SUNDRY NOTICES AND REPORTS ON WELLS

SJ 31-6 Unit #84

The subject well's APD was approved in August 2000 and plans were to only completed this well as a Pictured Cliffs well. Plans are now changed and we will be completing this well as a Dakota/Mesaverde commingle well. Therefore, the name had to be changed to the San Juan 31-6 Unit #8M.

WELL LOCATION AND ACREAGE DEDICATION PLAT

WELL LOCATION AND ACREAGE DEDICATION PLAT

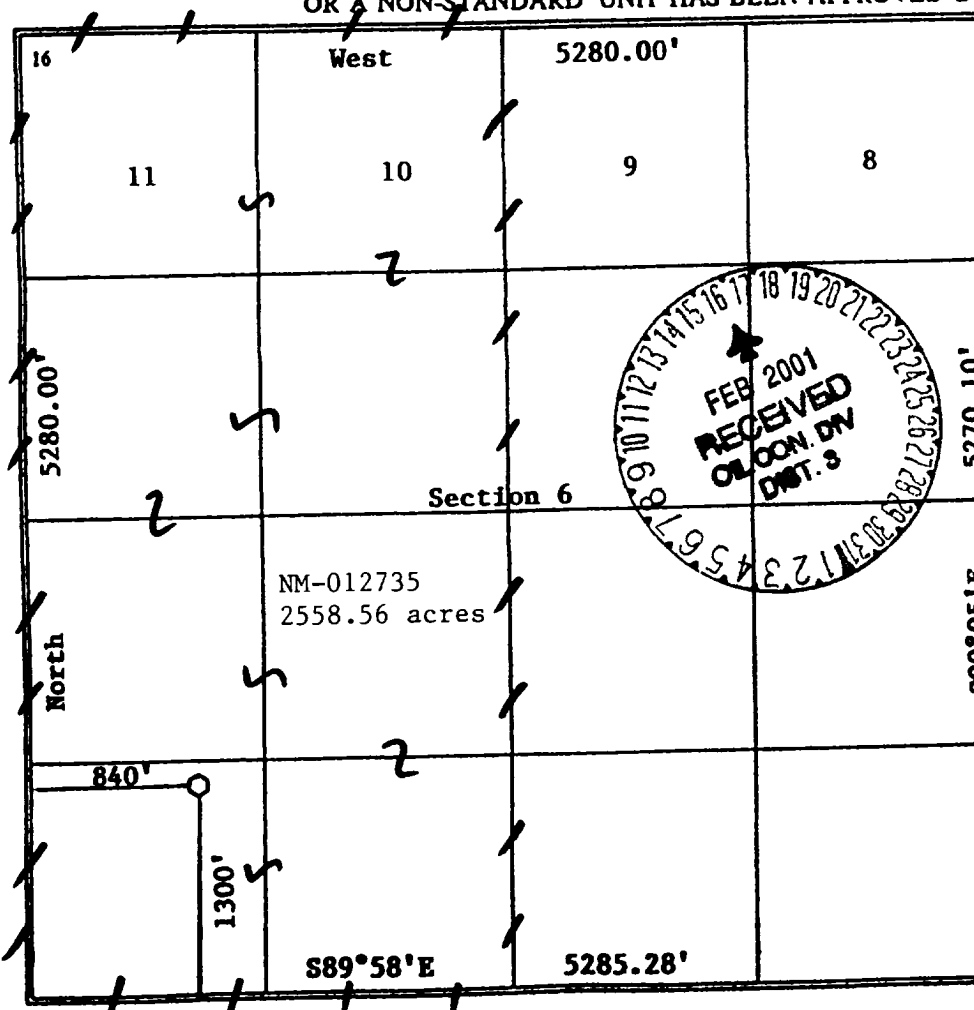
Attached are new C102s for both zones, as well as a new drilling prognosis. The surface location stayed the same, so the "Surface Use Plan" and pipeline information will remain the same.
